# Site Accessibility Evaluation

## Americans with Disabilities Act Title II (Public Services: State and Local Government)

### **DOT Operations Center**

**3275 Akers Dr  
Colorado Springs, CO  
80922**

### Finding: 1

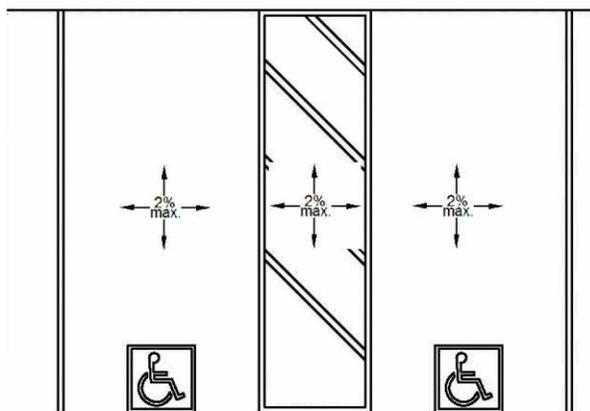
The running slope of the access aisle (long dimension) exceeds 2%.

Running slope ranges  
from 1% and 9.5%

Re-pave access aisle and ensure a 2% maximum cross and running slope for the full length and width of the access aisle.

### Finding: 2

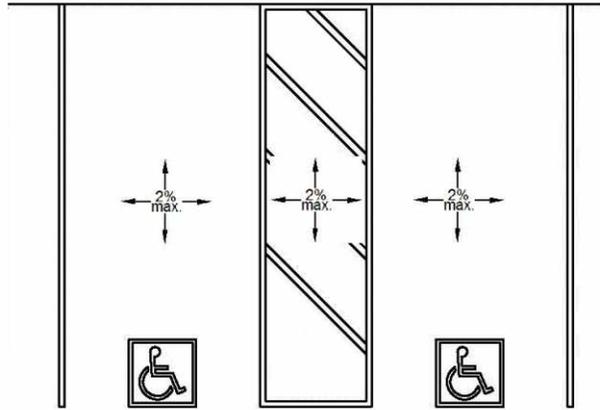
The running slope (long dimension) of the accessible parking stall exceeds 2%.

Running slope ranges  
from 1% up to 9.5%

Re-pave designated ADA parking stalls and ensure a 2% maximum cross and running slope for the full length and width of the parking stalls.

### Finding: 3

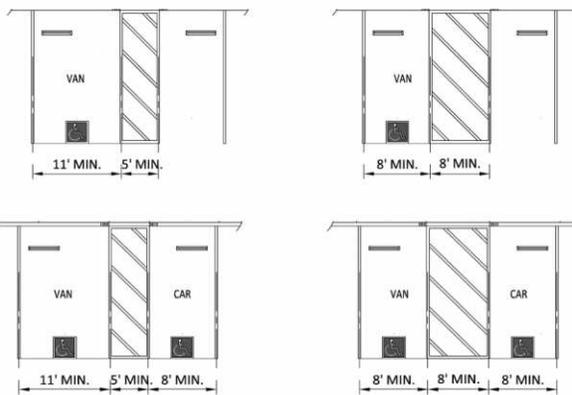
The accessible parking stall is not wide enough.

Van parking stall  
measures 9.8 feet in  
width

Re-stripe ADA parking stall/s and access aisle/s. ADA parking stalls shall measure 8 ft minimum in width measured to the centerline of the paint stripes. Access aisles shall measure 5 ft minimum in width measured to the centerline of the paint stripes. Ensure ADA van parking stall/s are 8 feet wide minimum with an access aisle of 8 feet wide minimum or 11 feet wide minimum with an access aisle of 5 feet wide minimum measured to the centerline of the paint stripes.

### Finding: 4

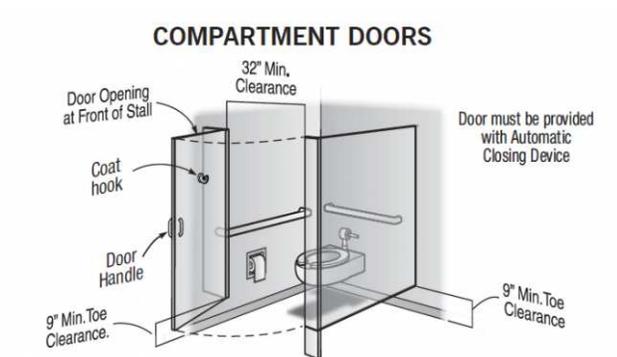
The compartment door is not self closing.

Compartment door not self closing

Adjust or install automatic closing hinges.

Corrective Action: W/O 381195 submitted.

### Finding: 5

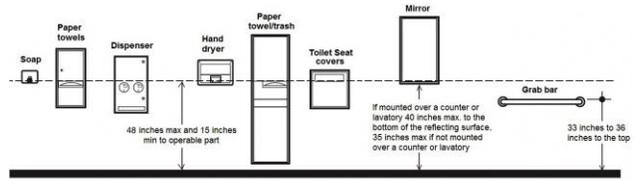
The toilet seat cover dispenser is mounted too high.

Citation:	As Built:	Budgeting Range:
2010 ADAS Section: 308.1	53 inches above finished floor	\$150 - \$1,500.00

Re-locate toilet seat cover dispenser below either grab bar at least 1.5 inches minimum below grab bars but no less than 15 inches above finished floor to meet compliance.

Corrective Action: W/O 392073 submitted. Relocated seat cover dispenser-Completed, 3/10/2017.

### Finding: 6

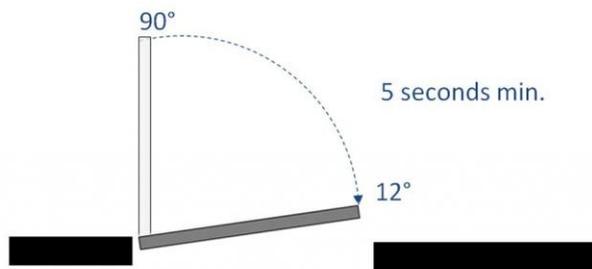
The door is equipped with a door closer and returns to a closed position too quickly.

Door from hallway to vestibule closed in 1.38 seconds and door from vestibule to restroom closed in 2.14 seconds.

Adjust both door closers to allow a minimum of 5 seconds to move from the open position at 90 degrees to 12 degrees from the latch/locking mechanism.

Corrective Action: W/O 386077 submitted.

### Finding: 7

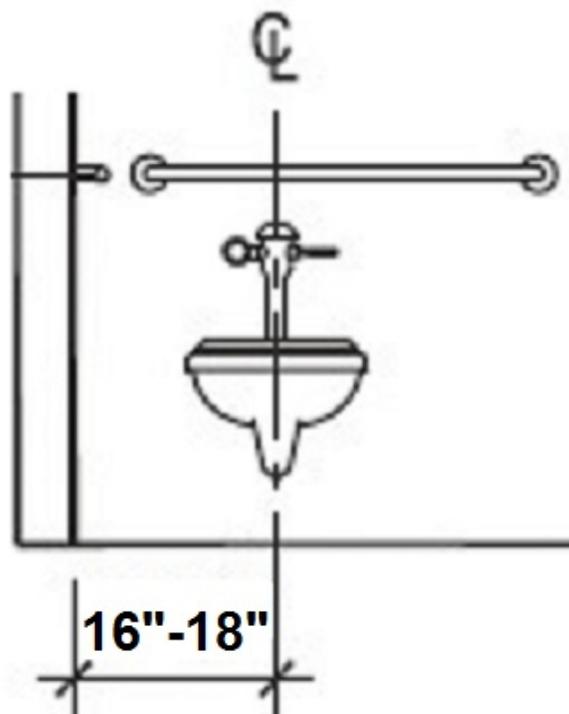
The toilet is not located within the range allowed from the side wall or partition.

18.5 inches from side wall

Re-position toilet between 16 inches minimum and 18 inches maximum from centerline of toilet to side wall. May require plumbing alteration.

### Finding: 8

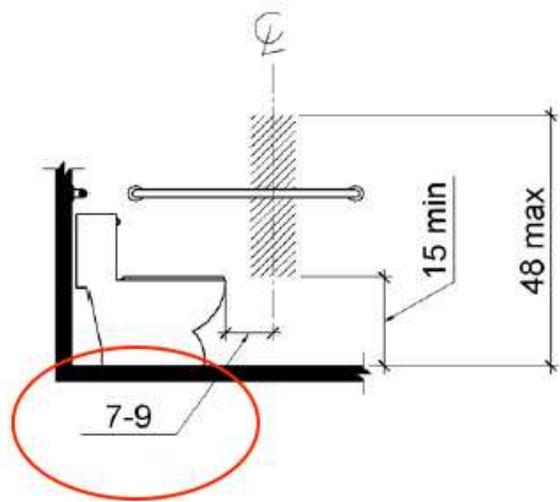
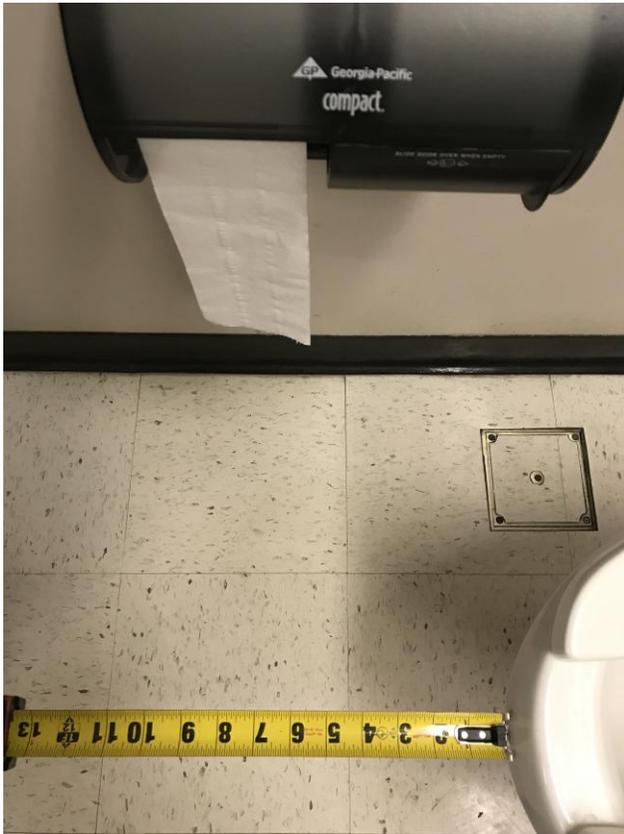
The toilet paper is not installed within the compliant range.

5 inches in front of toilet

Re-position toilet paper dispenser to be within 7 inches minimum to 9 inches maximum in front of the toilet measured to the centerline of the dispenser.

### Finding: 9

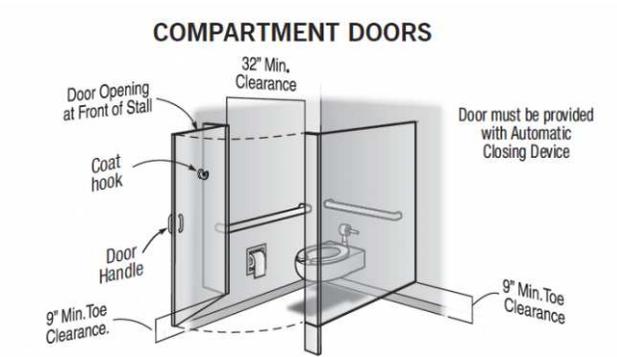
The compartment door is not self closing.

Compartment door not self closing

Adjust or install automatic closing hinges.

Corrective Action: W/O 381190 submitted.

### Finding: 10

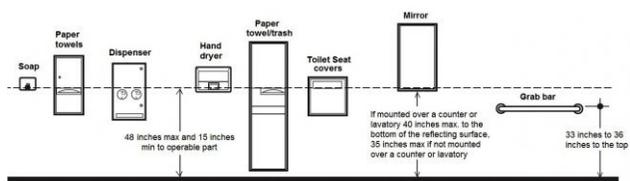
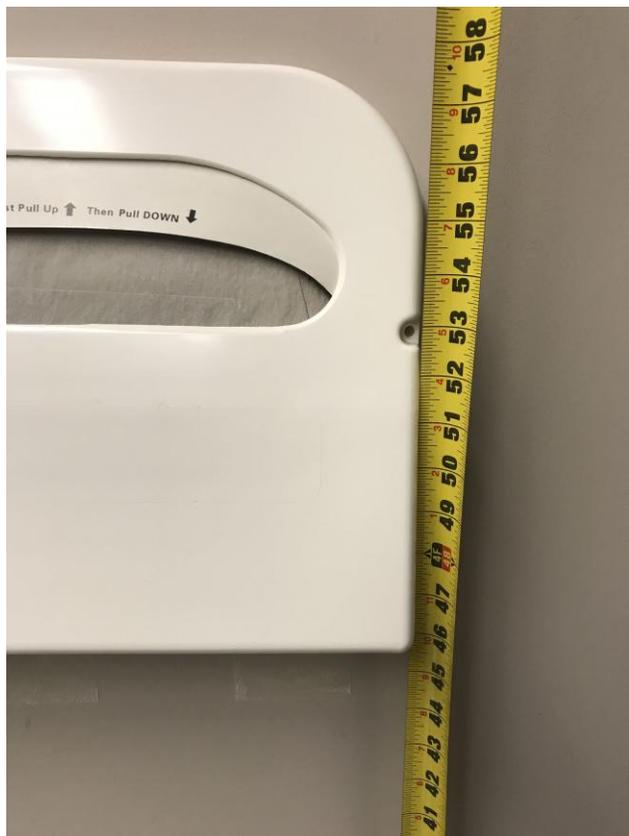
The toilet seat cover dispenser is mounted too high.

Citation:	As Built:	Budgeting Range:
2010 ADAS Section: 308.1	53 inches above finished floor	\$150 - \$1,500.00

Re-locate toilet seat cover dispenser below either grab bar at least 1.5 inches minimum below grab bars but no less than 15 inches above finished floor to meet compliance.

Corrective Action: W/O 392072 submitted. relocated seat cover-completed 3/10/2017.

### Finding: 11

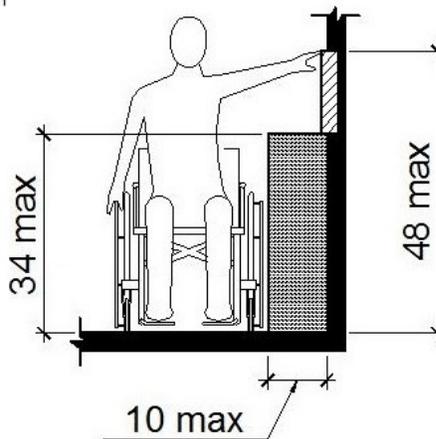
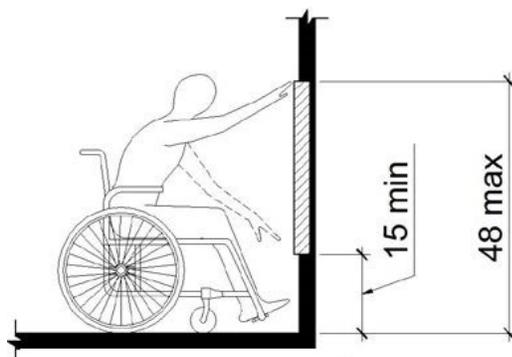
The coat hook is installed greater than 48 inches above the finished floor.

58 inches above  
finished floor

Lower coat hook 12 inches minimum or install another coat hook not to exceed a maximum height of 48 inches above finished floor.

### Finding: 12

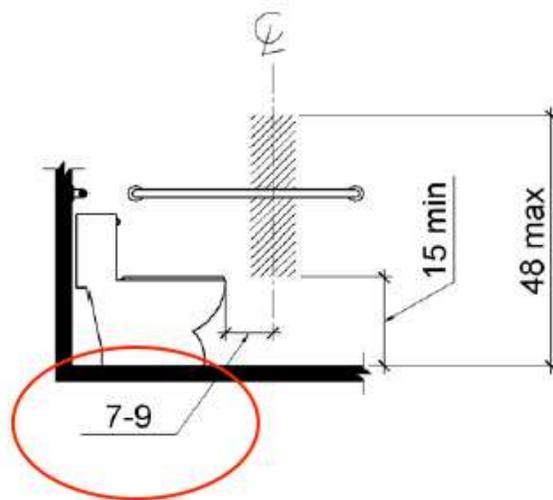
The toilet paper is not installed within the compliant range.

4 inches in front of toilet

Re-position toilet paper dispenser to be within 7 inches minimum to 9 inches maximum in front of the toilet measured to the centerline of the dispenser.

### Finding: 13

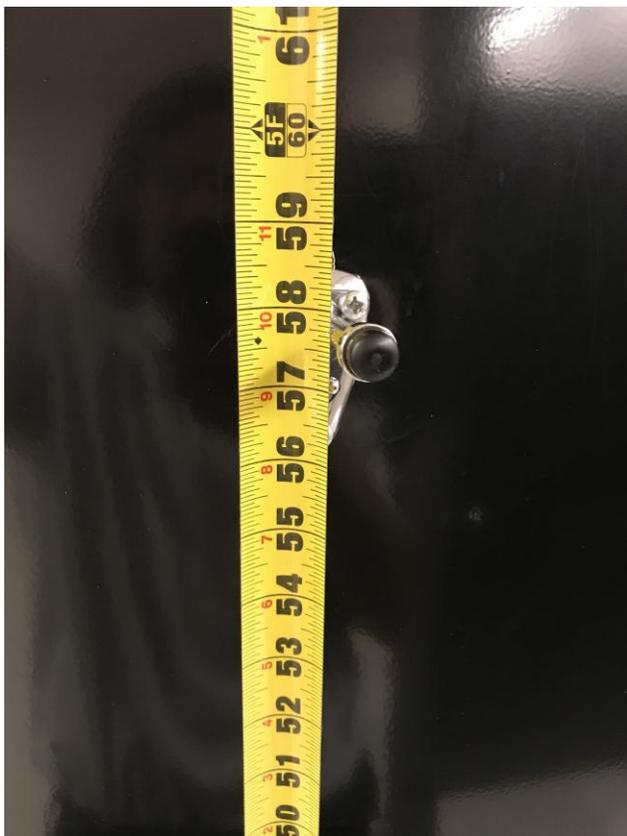
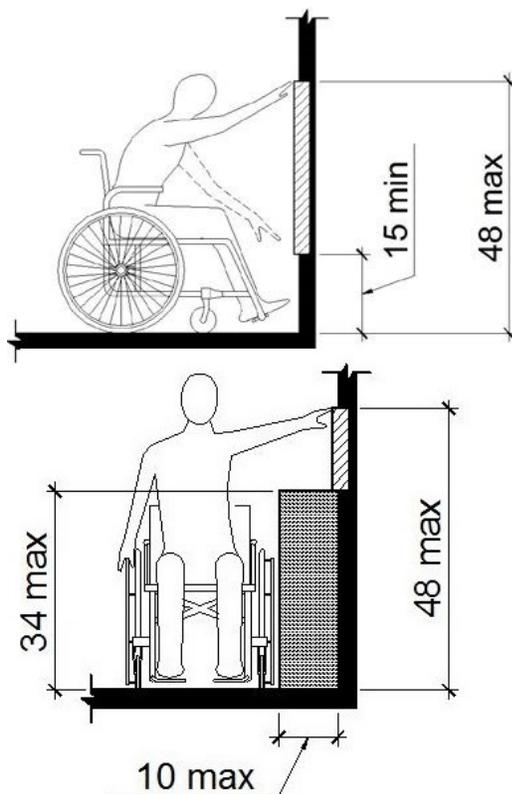
The coat hook is installed greater than 48 inches above the finished floor.

57.5 inches above  
finished floor

Lower coat hook 10 inches minimum or install another coat hook not to exceed a maximum height of 48 inches above finished floor.

### Finding: 14

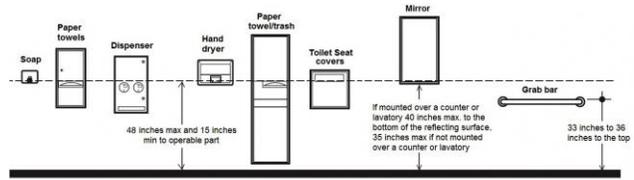
The toilet seat cover dispenser is mounted too high.

Citation:	As Built:	Budgeting Range:
2010 ADAS Section: 308.1	53 inches above finished floor	\$150 - \$1,500.00

Re-locate toilet seat cover dispenser below either grab bar at least 1.5 inches minimum below grab bars but no less than 15 inches above finished floor to meet compliance.

### Finding: 15

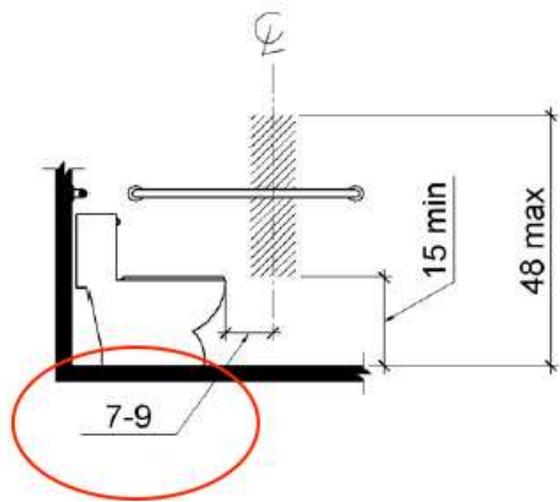
The toilet paper is not installed within the compliant range.

6 inches in front of toilet

Re-position toilet paper dispenser to be within 7 inches minimum to 9 inches maximum in front of the toilet measured to the centerline of the dispenser.

### Finding: 16

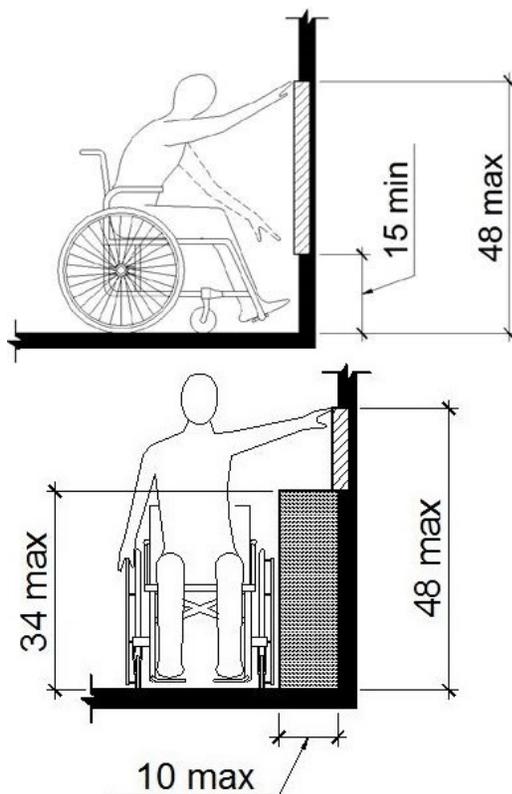
The coat hook is installed greater than 48 inches above the finished floor.

57.5 inches above  
finished floor

Lower coat hook 10 inches minimum or install another coat hook not to exceed a maximum height of 48 inches above finished floor.

### Finding: 17

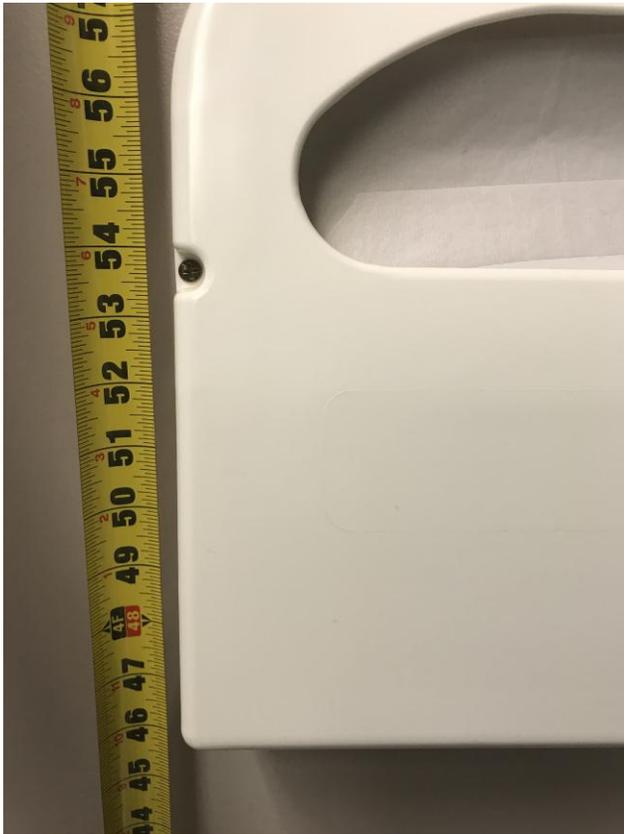
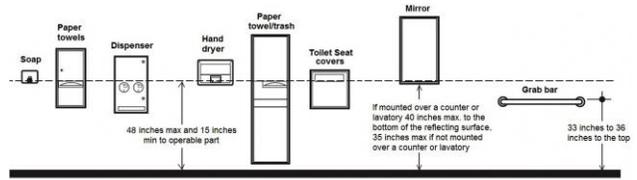
The toilet seat cover dispenser is mounted too high.

Citation:	As Built:	Budgeting Range:
2010 ADAS Section: 308.1	53.5 inches above finished floor	\$150 - \$1,500.00

Re-locate toilet seat cover dispenser below either grab bar at least 1.5 inches minimum below grab bars but no less than 15 inches above finished floor to meet compliance.

### Finding: 18

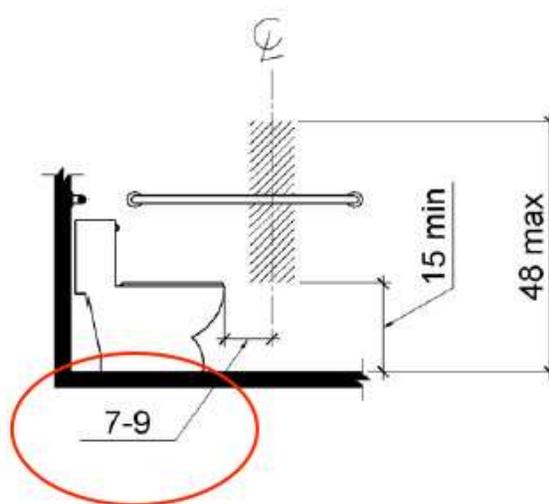
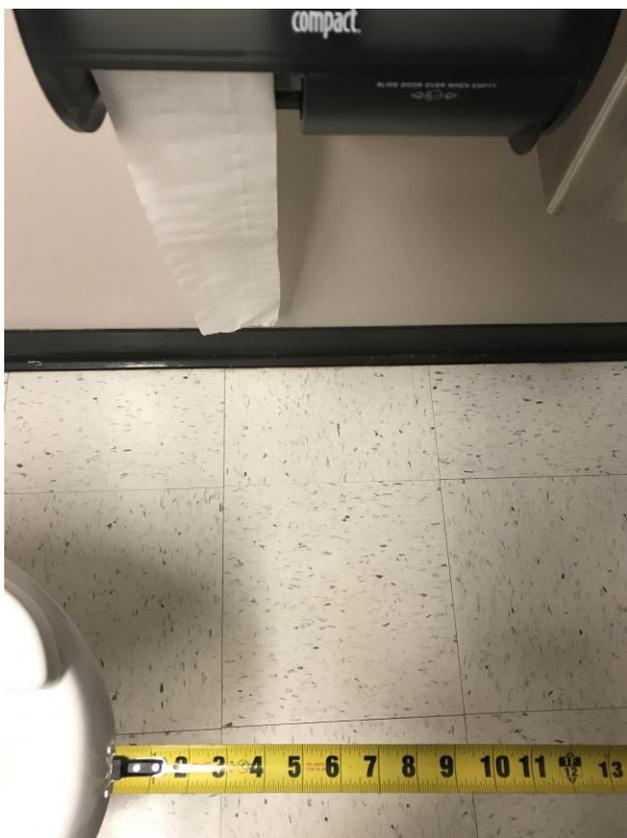
The toilet paper is not installed within the compliant range.

5.5 inches in front of toilet

Re-position toilet paper dispenser to be within 7 inches minimum to 9 inches maximum in front of the toilet measured to the centerline of the dispenser.

### Finding: 19

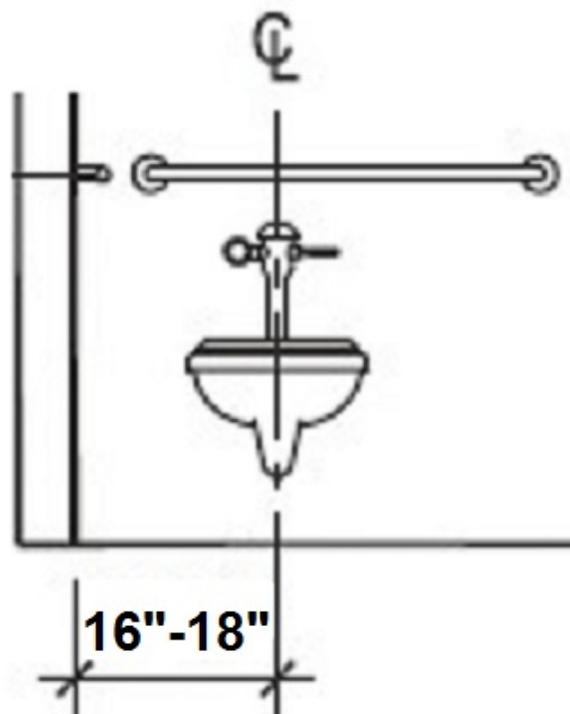
The toilet is not located within the range allowed from the side wall or partition.

<b>Citation:</b>	<b>As Built:</b>	<b>Budgeting Range:</b>
2010 ADAS Section: 604.2	19 inches from side wall	\$1,500 - \$6,500.00

Re-position toilet between 16 inches minimum and 18 inches maximum from centerline of toilet to side wall. May require plumbing alteration.

### Finding: 20

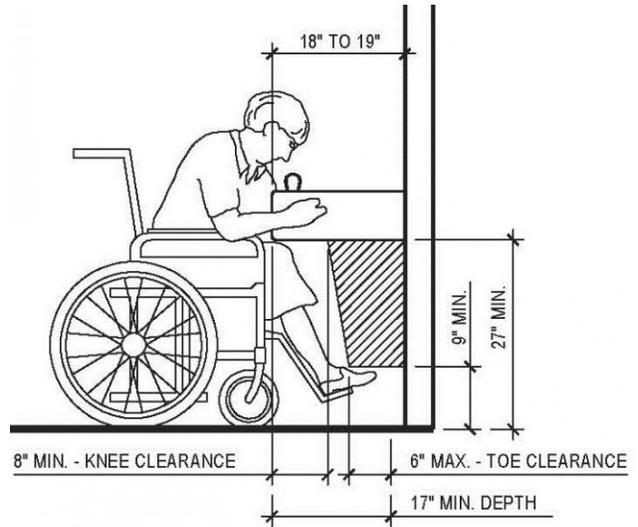
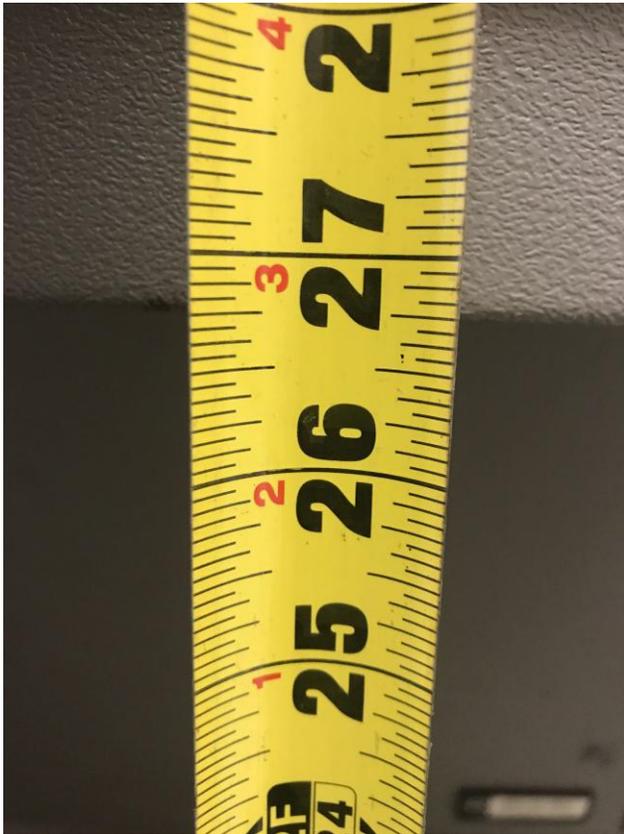
There is not enough knee clearance under the drinking fountain.

26.75 inches above  
finished floor

Adjust drinking fountain to meet the minimum 27 inches measured from the bottom edge of the drinking fountain to the top of the finished floor. This drinking fountain is located within an alcove. Recommend raising 1 inch.

### Finding: 22

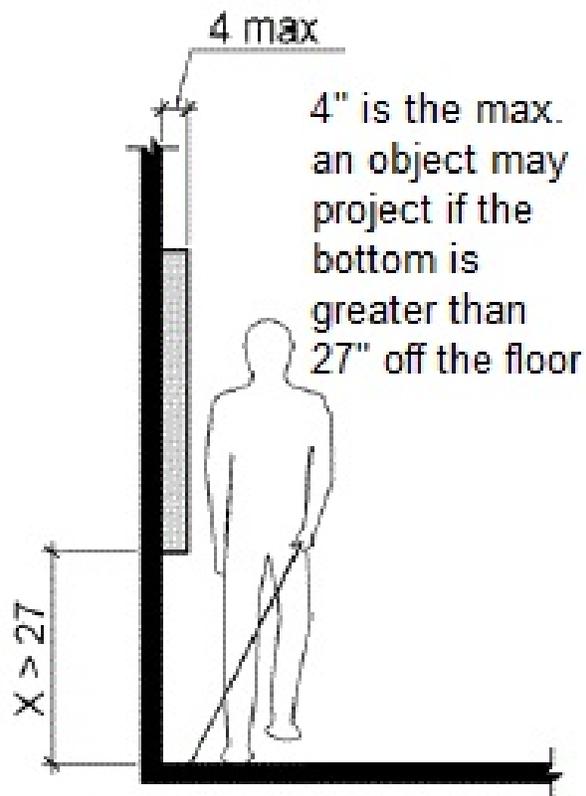
The suggestion box projects more than 4 inches into the circulation path.

Suggestion box  
protrudes 7 inches at  
52 inches above  
finished floor

Replace suggestion box with low profile box or place existing suggestion box in different location and not in a main path of travel.
